Proposed plan showing pedestrian access to Bottleworks Square

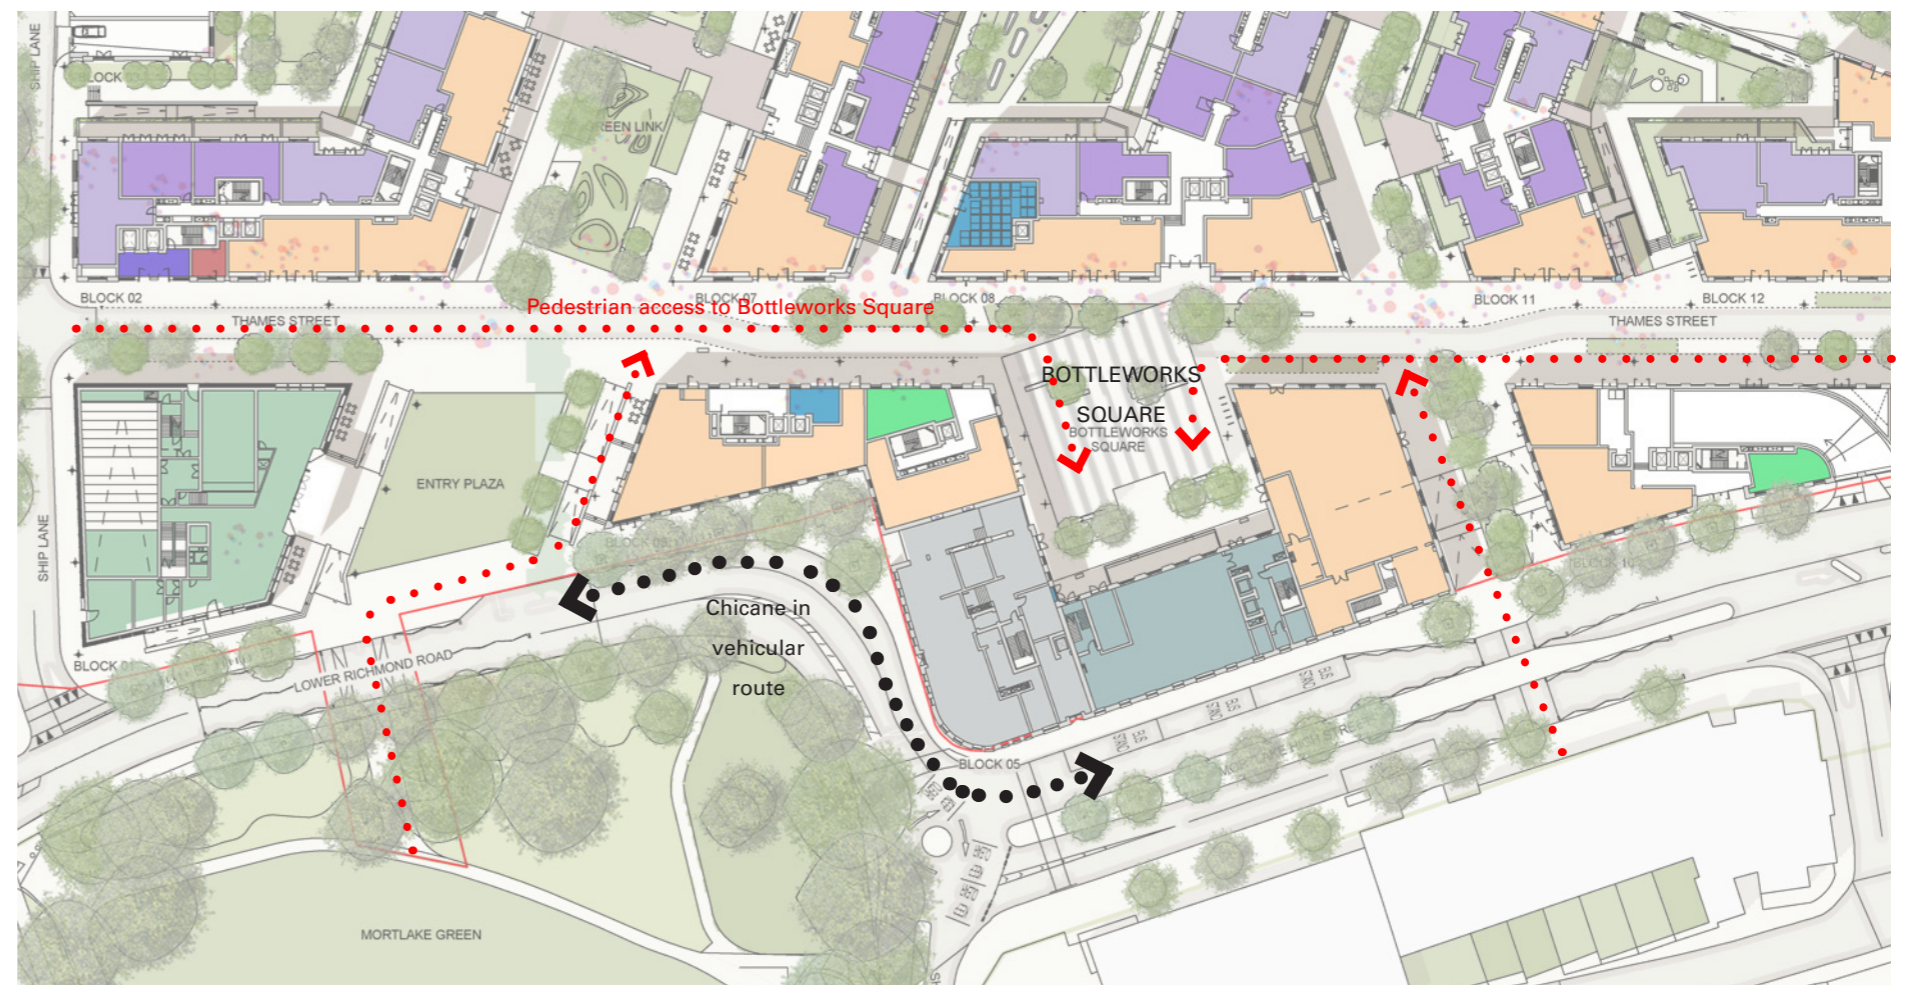
2. Access to Bottling Square seems rather torturous. How does access to square work?

We would remind you that the green link had originally been proposed to begin at the corner of Lower Richmond Road (to the north west of the hotel). While this proposal stemmed from the Planning Brief diagram, it became apparent that a series of traffic constraints and safety issues make it unfeasible to provide a route in this location. It is these safety issues that have guided the proposal to deliberately prevent pedestrians from cutting across this potentially dangerous chicane in the existing road.

The Bottling Square is instead conceived as a public space that is accessible off the main new 'High Street' route. This widened public space serves to add variety to the streetscape and provide the potential for events to be held in the space.

It is not unusual to come across an 'unexpected' public space within a townscape - a space that is not immediately apparent within the townscape on approach from the periphery of the area. Many British and European cities benefit from strong urban spaces such as these and notable example is St Christopher's Square in Central London.

Revised east elevation of hotel

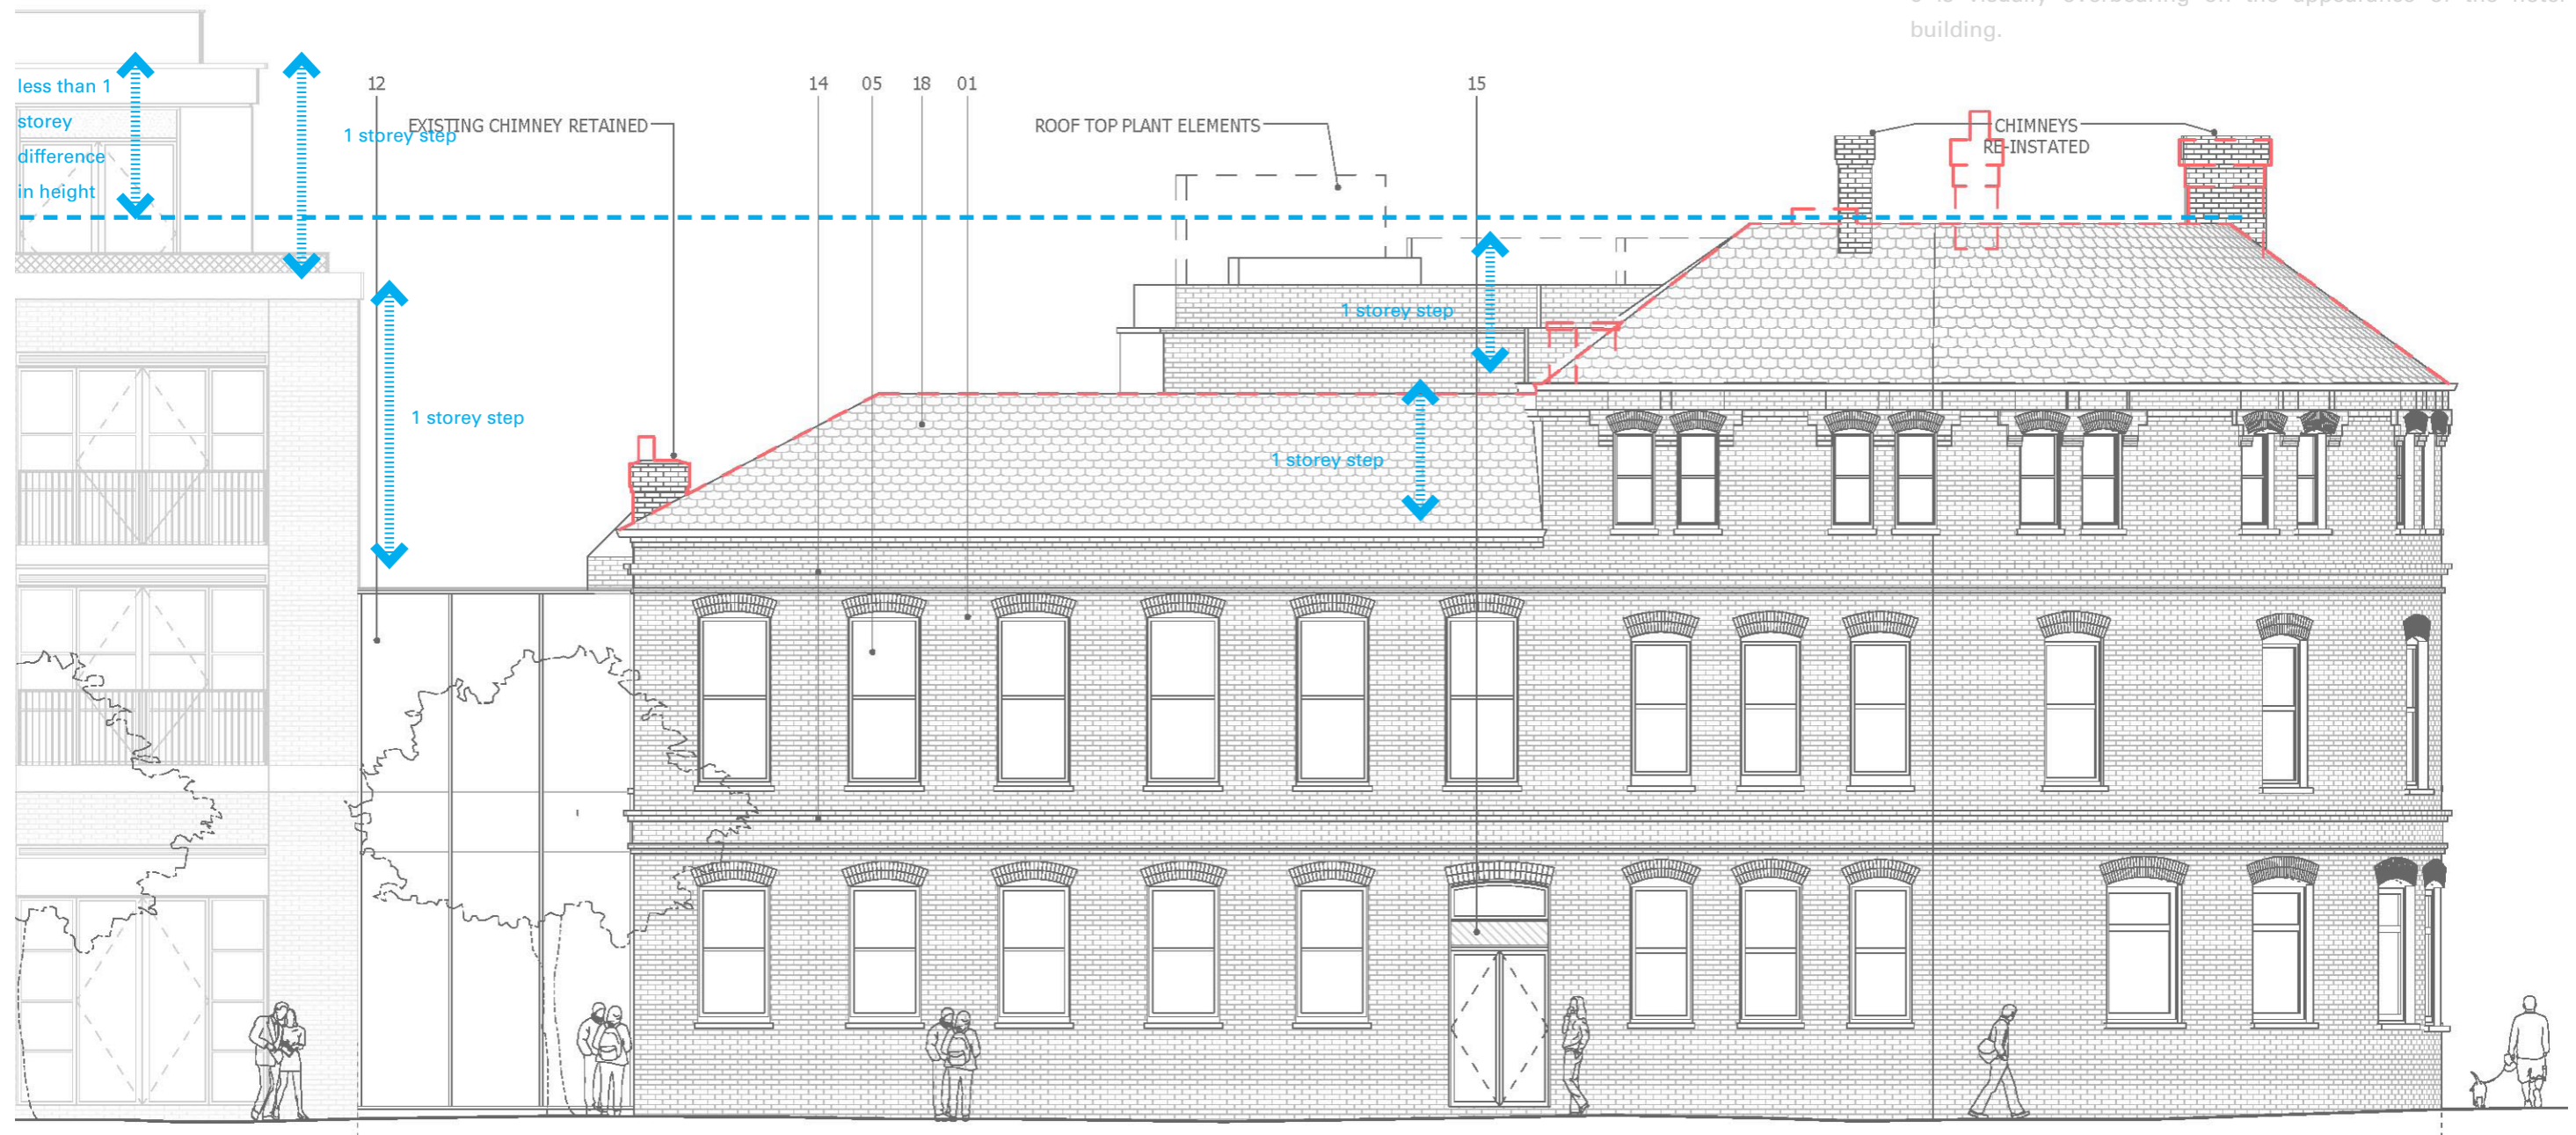
- The chimneys are an important visual element of the hotel roofscape and should be retained for the corner landmark hotel. They are shown in the D+A statement vol2 as retained (p56), but shown removed in the planning application drawings – eg in D+A Statement vol5 – there are also some differences of fenestration. Removal of slate roof and chimneys are unacceptable. This would be damaging to the character of the BTM, architectural integrity and historic interest. The chimneys are an important part of the overall composition of the hotel roofline. The Heritage statement does not cover this issue. Retain chimneys and clarify differences in fenestration. The heritage statement does not cover this issue.

- Confusion over the roof materials of the hotel. Metal roof is shown on the application drawings, which is completely unacceptable, damaging to the character of the BTM, architectural integrity and historic interest – the hotel roof is in a pivotal position. However, the D+A S Vol 2 says ‘... slate roof to be reinstated’. Slate roof should be proposed/ reinstated.

Drawings have been revised to show re-instatement of chimneys (in slightly different positions that co-ordinate with the structure of the building below). It is not possible to retain the existing chimneys because the existing basement is proposed to be deepened.

The drawings have been revised to show the replacement roof material as slate.

Revised west elevation of hotel

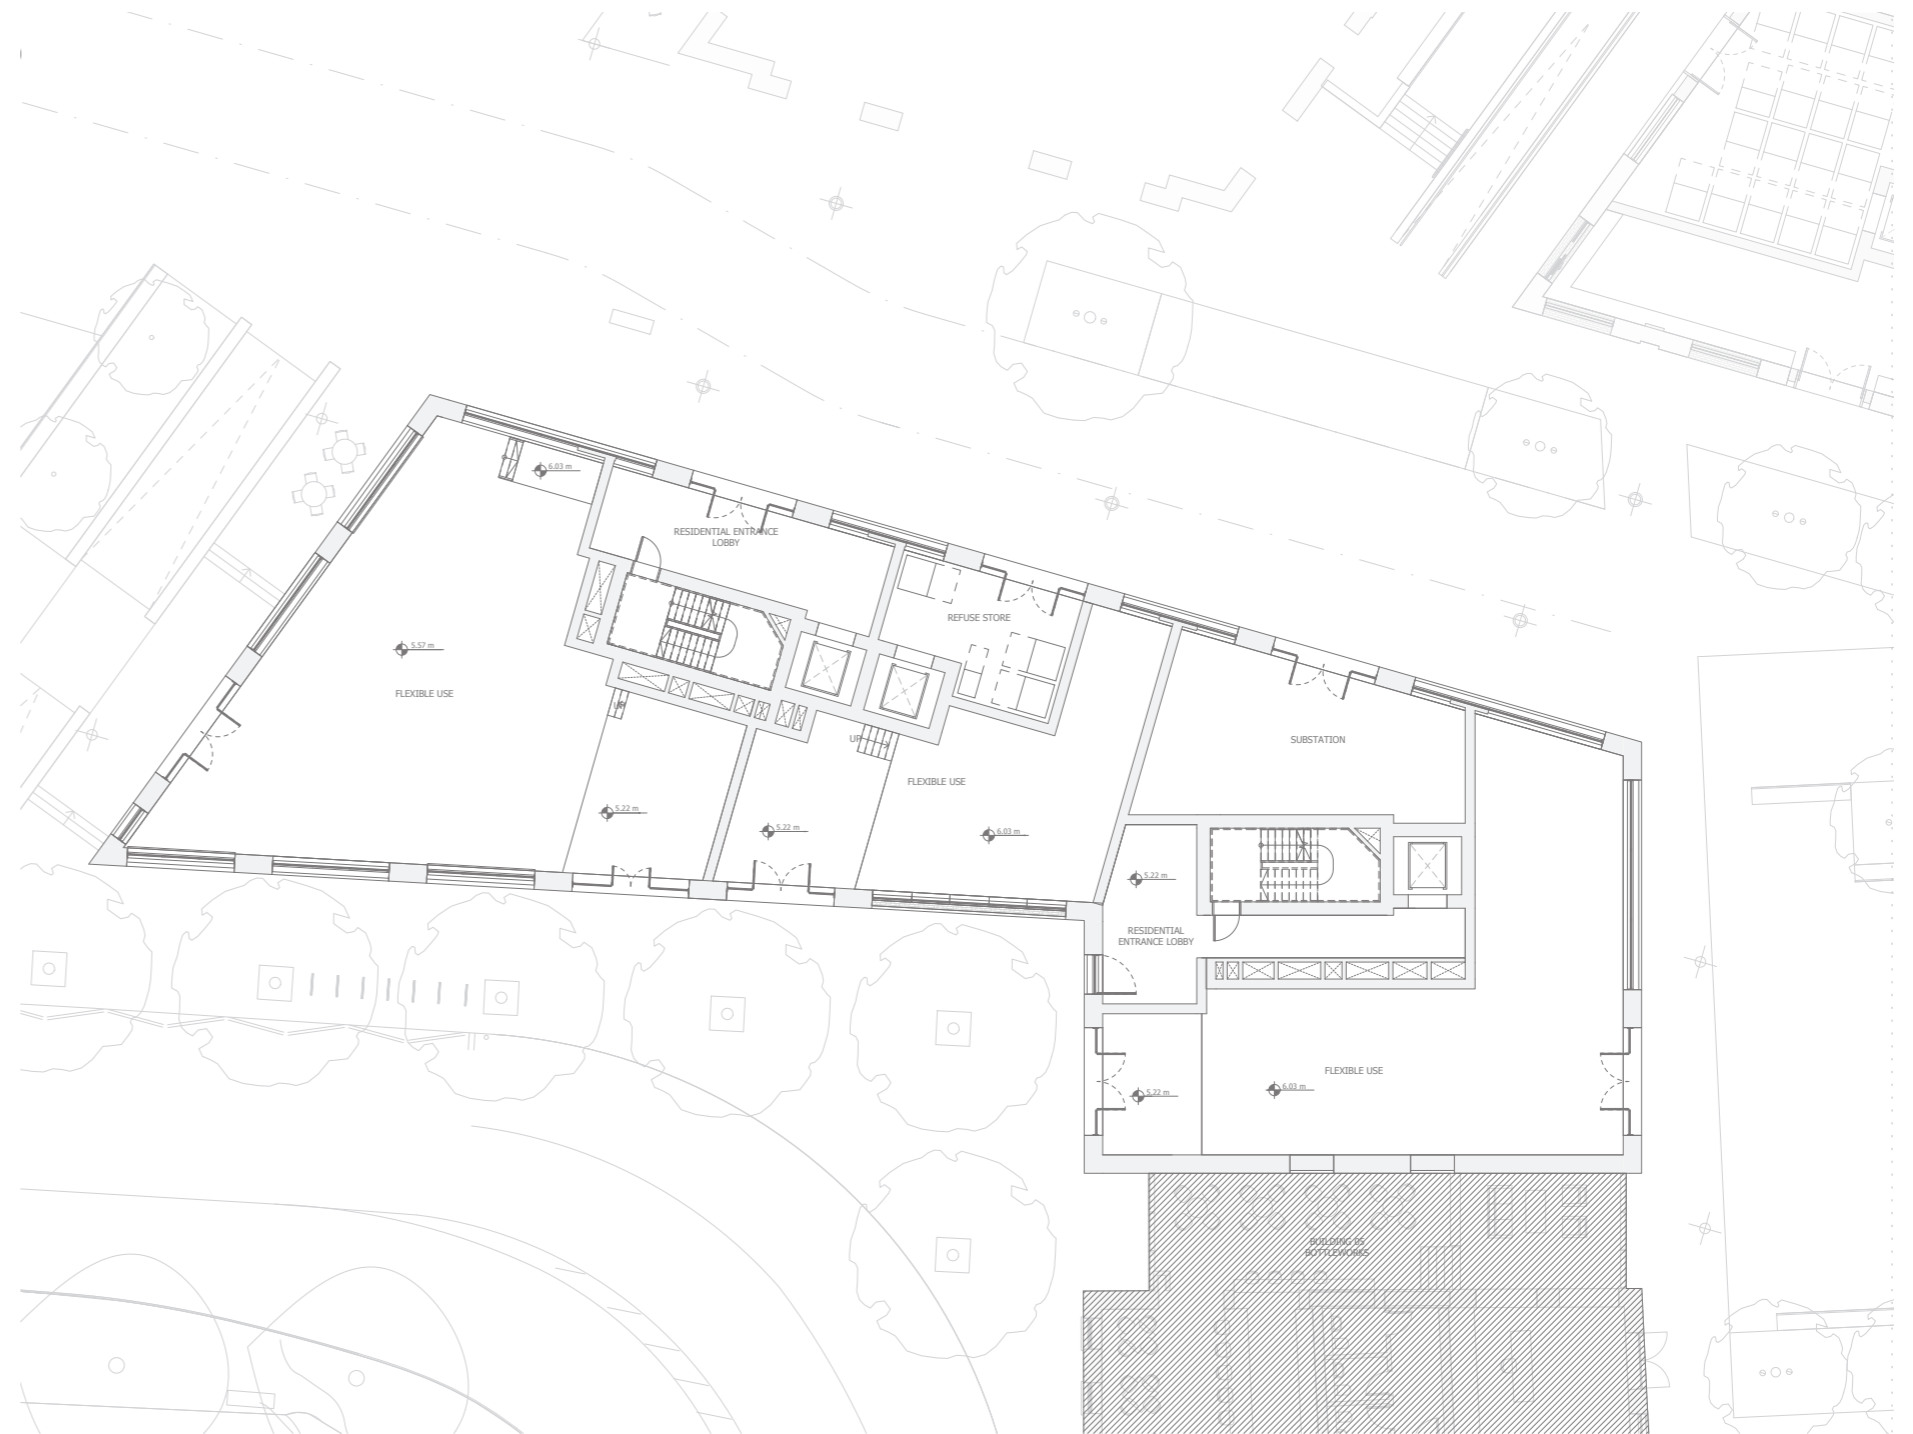
9. Uncomfortable 'proportion' relationship between building 6 and hotel. It is recommended the proportions reflect that of the hotel.

10. Remove glazed balustrade at roof level.

The existing hotel building is two/ three storeys high. The northernmost part of the building adjacent to Building 6 is two storeys and the three storey element steps up at the corner junction with Mortlake High Street. Building 6 is proposed as being three storeys high with an additional set back level. We do not believe that the resultant steps in building height are unacceptable since they are in single storey increments. Furthermore, we disagree that the stepped profile of Building 6 is visually overbearing on the appearance of the hotel building.

The roof level balustrade was proposed as a means of edge protection (from risk of falls) to any maintenance personnel when accessing roof top plant. We would not recommend removing this balustrade since this would pose a health and safety risk.

Proposed second floor plan of Buildings 5 and 6

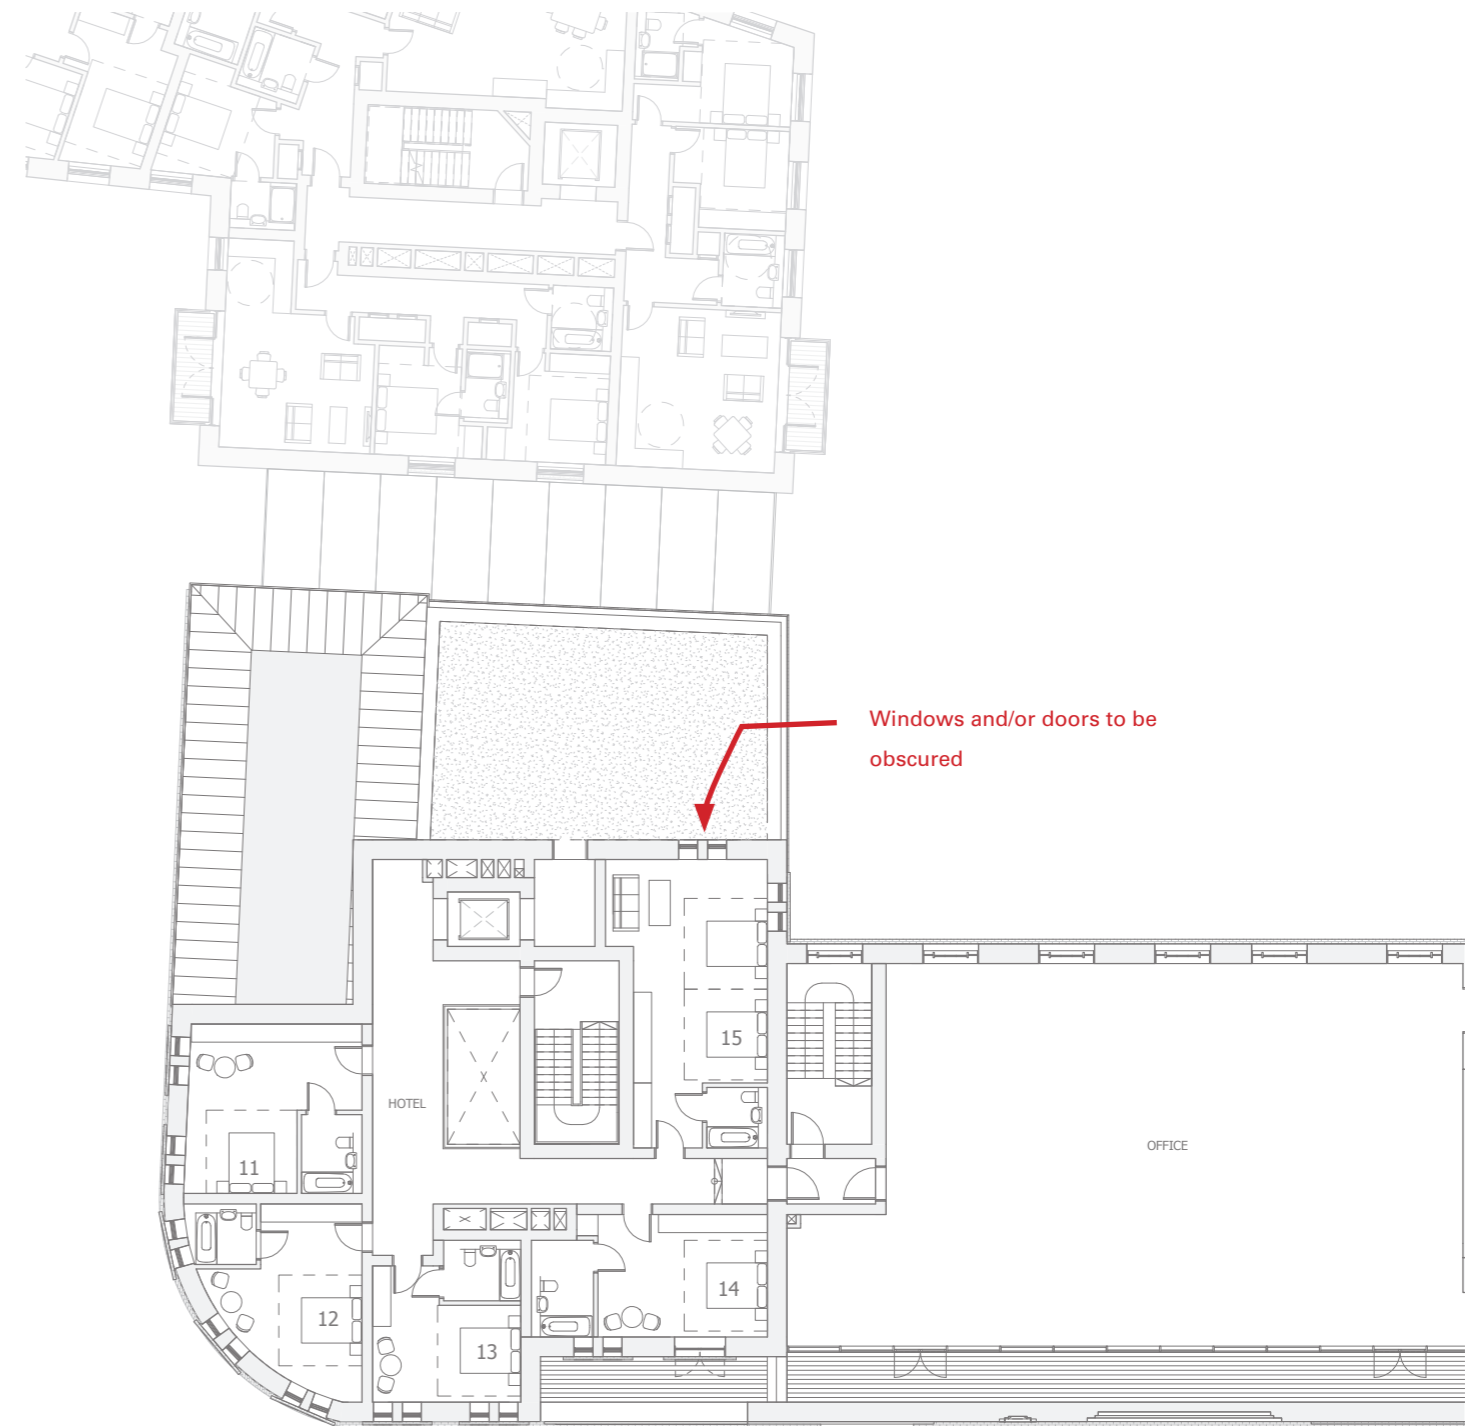
13. Block 6 and Block 5: only 4m gap between flat and wall. Unacceptable.

14. Block 6 with 7 and 8: only 16m gap. Unacceptable living conditions.

The 4 metre gap between the buildings is sufficient to clearly separate and distinguish the massing of Building 6 from the hotel building. The only windows that overlook from Building 5 towards Building 6 are to the set back elevation at second floor level of the hotel – we will be amending the elevation to either omit or obscure the hotel windows that face Building 6.

Please see section dedicated to 'Proximity of Buildings'.
